Item 4.**Development Application: 355-357 Sussex Street, Sydney - D/2022/417**

File No.: D/2022/417

Summary

Figure 16: Setback comparison between Pre-DA Scheme 1 (left) and revised Pre-DA Scheme 2 (right)

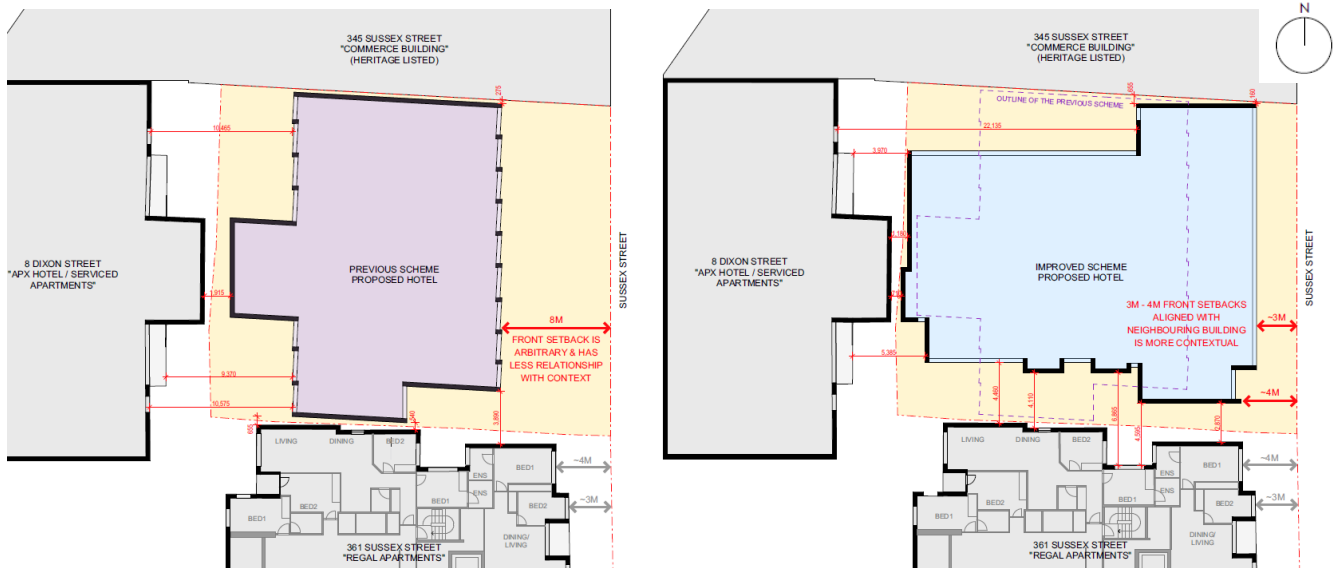
The first Pre-DA scheme was considered to provide a better outcome than the revised scheme in terms of street setbacks and alignment with the southern development (Regal Apartments). The street setback of 3 - 4 metres (2.3 metres clear setback measured to the outer face of facade elements) seeks a significant variation to Section 5.1.1.2 of Sydney DCP 2012 and is not supported. Council officers suggested a variation of 2 metres (a reduced street setback of 6 metres) may be acceptable on planning merits, factoring the constraints of the site, appropriate setback to the south, and in lieu of achieving additional separation to the rear (APX Apartments).

The proposal must provide a sufficient setback to the southern development which would allow facade maintenance of both buildings along the southern boundary, as well as amenity to the existing lightwell of the Regal Apartments.

Figure 52: Section showing extent of non-compliance

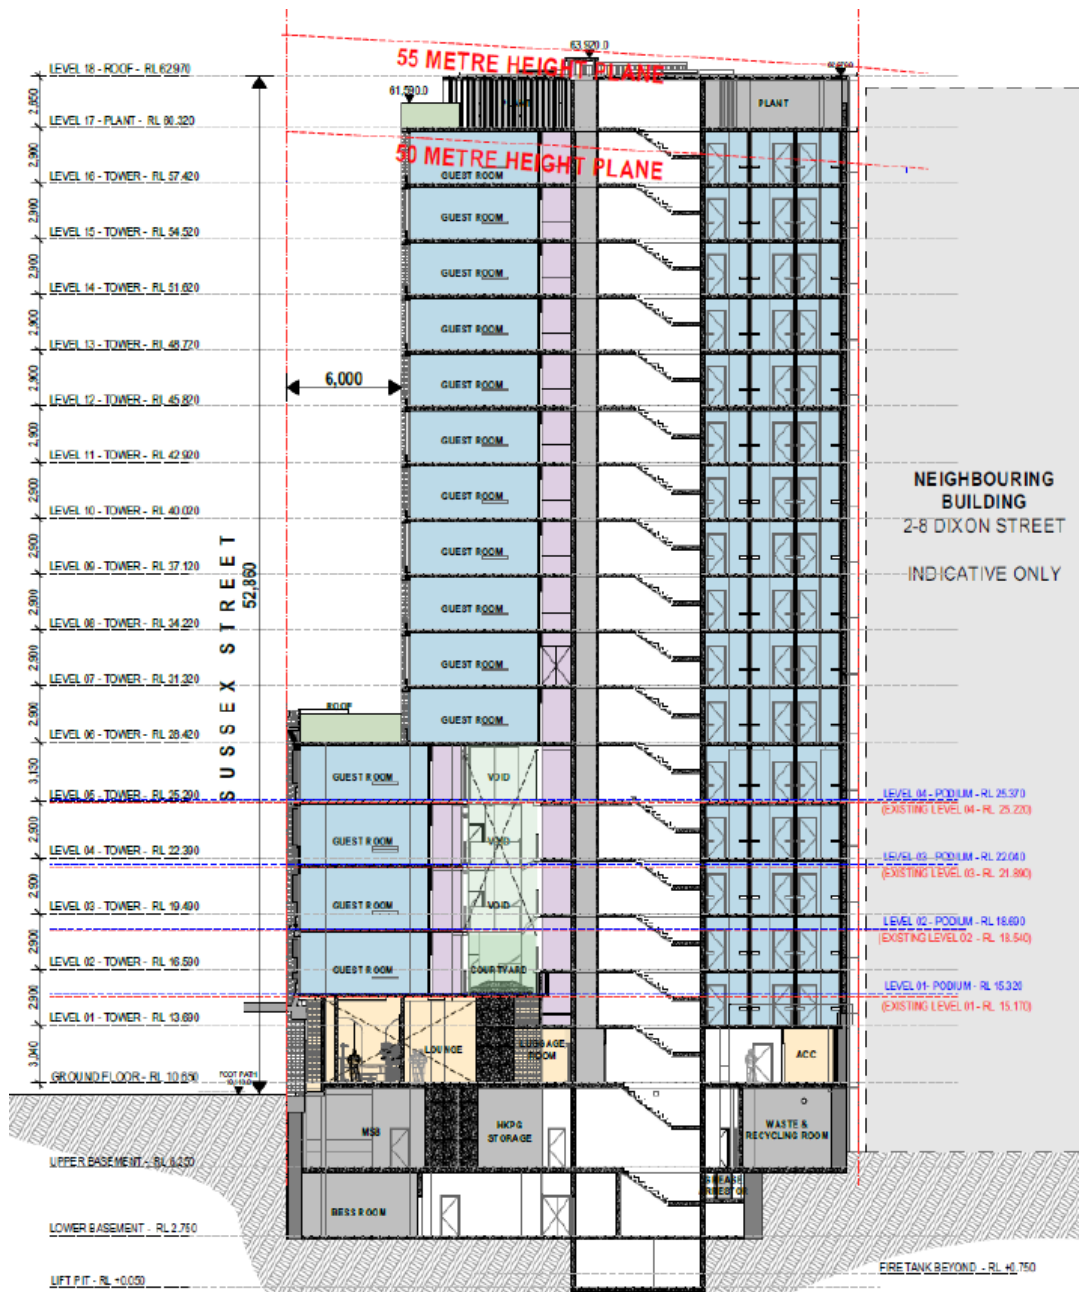
85. The site is permitted a maximum height of 50m under Clause 4.3 (Height of Buildings) of Sydney LEP 2012.
86. The proposed development has a maximum building height of 54.9 metres, which represents a 4.9 metre or 9.8 per cent variation to the height control. The exceedance results from part of level 16 and the roof of the development containing a plant room and lift overrun, with variations ranging from 2.085 metres (measured to the tower parapet) to 4.905 metres (measured to the plant/ lift overrun).

Figure 53: Prevailing Street wall height along Sussex Street, local heritage items at 345B Sussex Street (Former Commerce Building, 1966) and 365-375 Sussex Street (Former Commerce House, 1967) shown hatched in brown

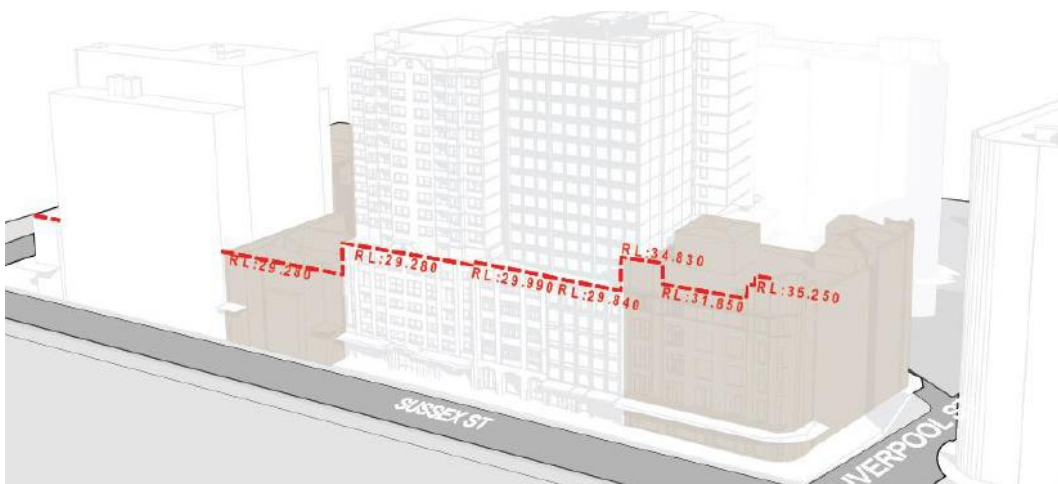
The proposal is consistent with the existing and future pattern of development in the City, is visually compatible with neighbouring properties, whilst maintaining the existing established street wall height of the locality (refer to Figure 53 below).

112. In addition, the applicant has undertaken a street wall analysis (Figure 53) to assess the existing and proposed context of buildings along the western side of Sussex Street at this location. The analysis shows a prevailing street wall height ranging between 19.3 metres to 24.8metres.

Figure 55: Hourly overshadowing analysis of the proposal at mid-winter (21 June). Overshadowing impacts resulting from a compliant building height (50m) shown in green, additional overshadowing impact resulting from the additional height (54.9m) shown in blue.

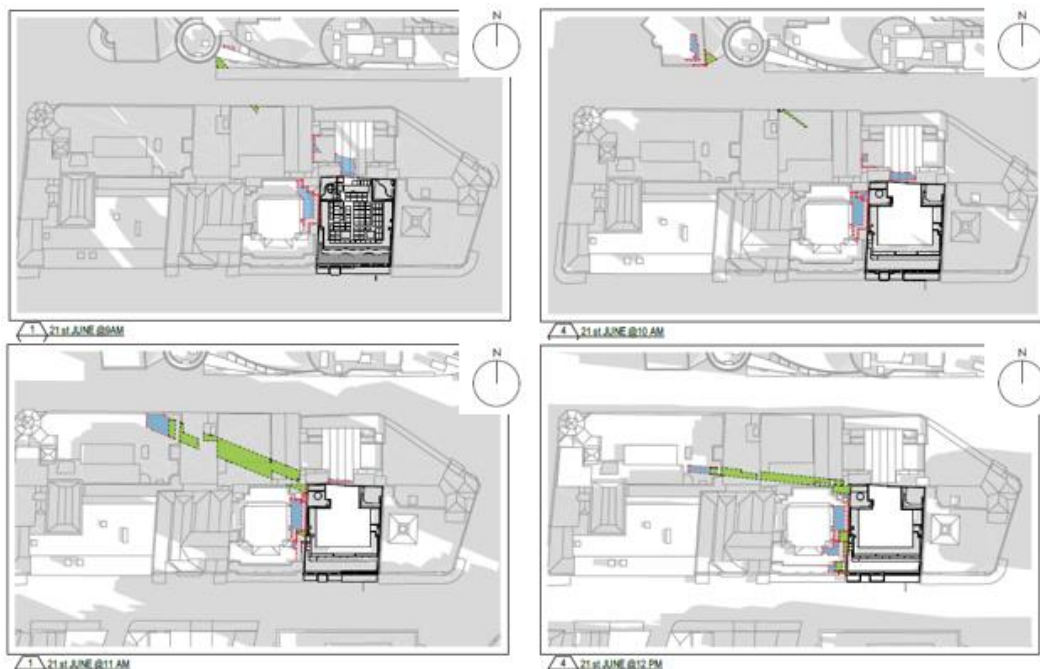
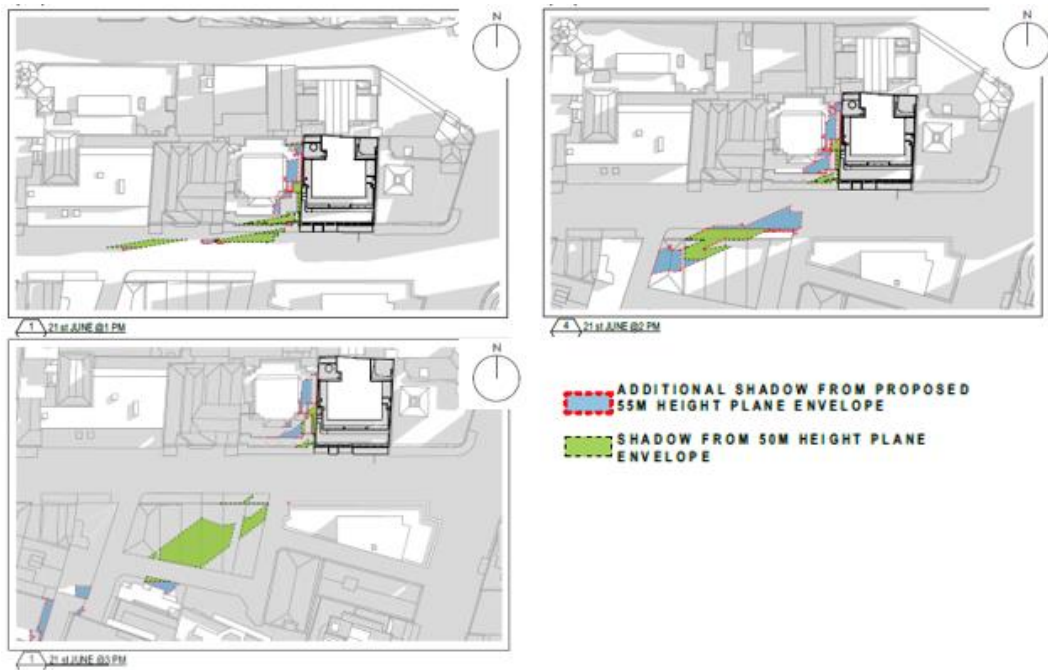
- (b) Overshadowing of the northern lightwell of the Regal Apartments that services bedrooms and an ensuite. The proposal will not impact primary living areas or private open space of the Regal Apartments which are orientated east or west, away from the subject site.

- (c) Overshadowing of the south-eastern APX Apartments between 9am and 12pm. The east facing studios (living rooms and balconies) located at the south-eastern portion of 2-8 Dixon Street are already subject to overshadowing due to the existing lift core of the APX Apartments. The increased overshadowing resulting from the proposed development relates to ensuite windows at 9am.

103. It is considered that the minor increase in overshadowing impacts to the Regal Apartments and APX Apartments is acceptable in this instance having regard the dense urban context and transitioning built form in the area and sufficient separation being achieved. The slight increase in overshadowing resulting from the proposal primarily affects direct sunlight received to bedrooms/ensuites of the adjacent units. Sufficient building separation of approximately 12 metres has been provided to ensure daylight access to the east facing APX Apartments is preserved. The proposal will maintain the existing level of amenity of primary living areas and private open space areas of the adjacent apartments.

Figure 64: Proposed Level 4 Floor Plan (left) and East Elevation (right)

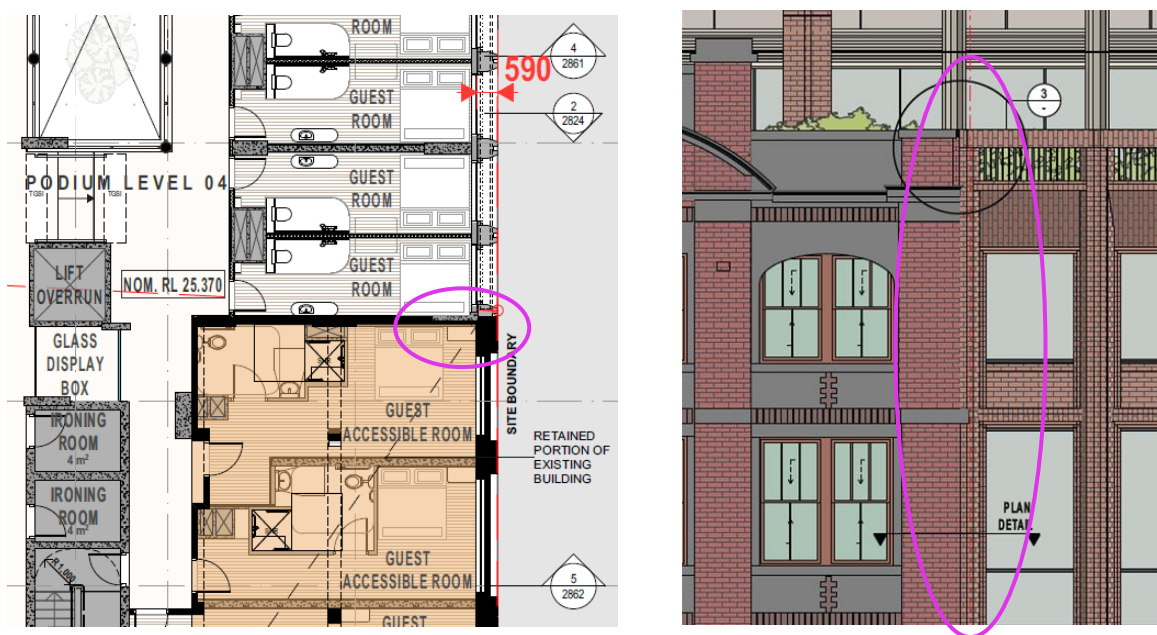
121. It is noted that there are slight discrepancies between the proposed demolition plan, proposed plans and elevations. The demolition plans show partial retention of the northern party wall (depth of two bays) including architectural decoration and cornices. While the proposed plans and east elevation shows the overlapping portion of wall as partly removed. The width of the existing cornice appears to be of a lesser dimension in elevation than surveyed (refer to Figures 63 and 64). The architectural plans show a new structural column/ blade wall abutting the retained facade which appears slightly out of alignment when compared to the structural drawings (as shown in Figure 65).

Figure 66: Extract of an Axonometric Diagram and Basement Floor Plan from the Structural Report prepared by Van Der Meer

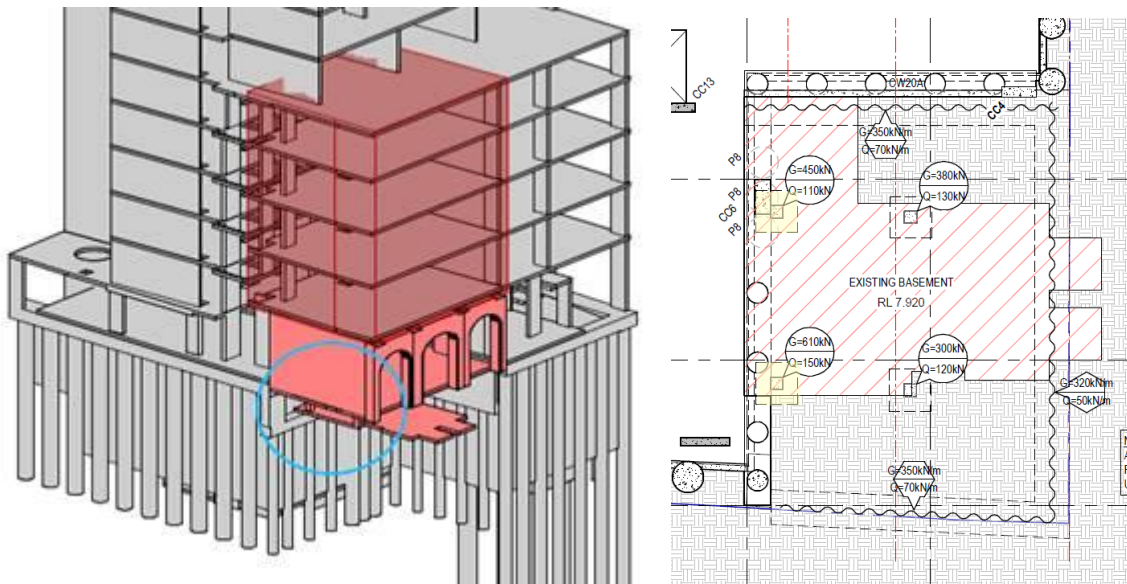
123. The proposal, as amended, comprises the retention of the existing floor levels of 357 Sussex Street. However, the submitted structural plans shows piling close to the foundations of the existing columns (possibly under the footings of the existing columns) as shown the following Figure 66.
124. Similarly, the proposed demolition plan shows removal of existing engaged piers under the southern party wall (as shown in Figures 29 and 30).
125. Conditions are recommended to ensure any proposed piling and structure does not interfere with the existing structure of the two retained bays including the zone of influence of its footings, and the existing engaged piers situated along the southern boundary are not to be removed without structural verification.

Figure 67: Proposed eastern elevation tower parapet

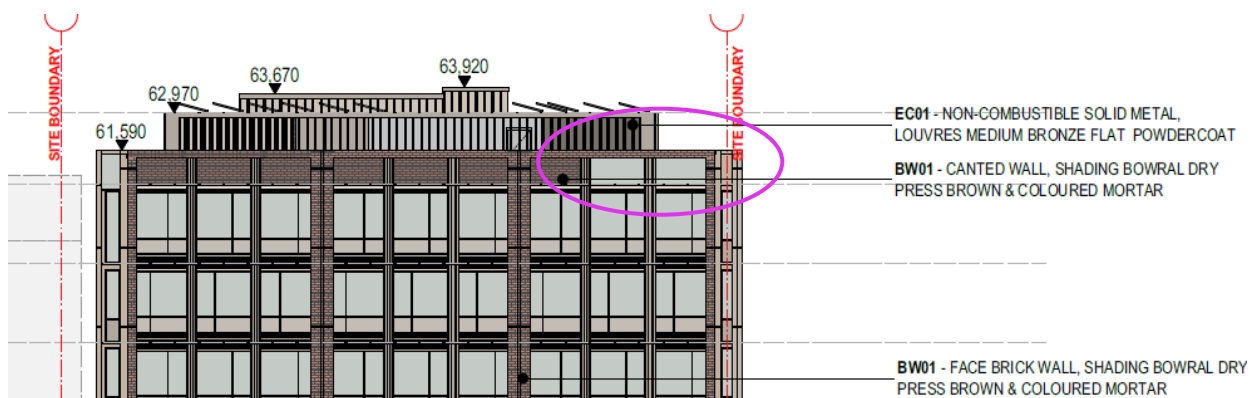
127. The proposed tower parapet on the eastern elevation fronting Sussex Street comprises a brick canted wall, with the exception of the northern two bays which are proposed to be glazed (Figure 67). The parapet conceals building services and the level 17 plant.

128. The proposed change in materiality from brick to glazing is considered contrary to Section 5.1.4(6) of Sydney DCP 2012 and as such is not supported. A consistent brick parapet is appropriate given the site context, as it will contribute towards the masonry character of the building, conceal plant/ building services, and proportionately provide a 'finish' to the top of the building.
129. There are also insufficient details on how the proposed canted wall will be constructed (refer to Figure 68). The proposed construction of the parapet is to reduce opportunities for stormwater run-off that can stain the building facade.
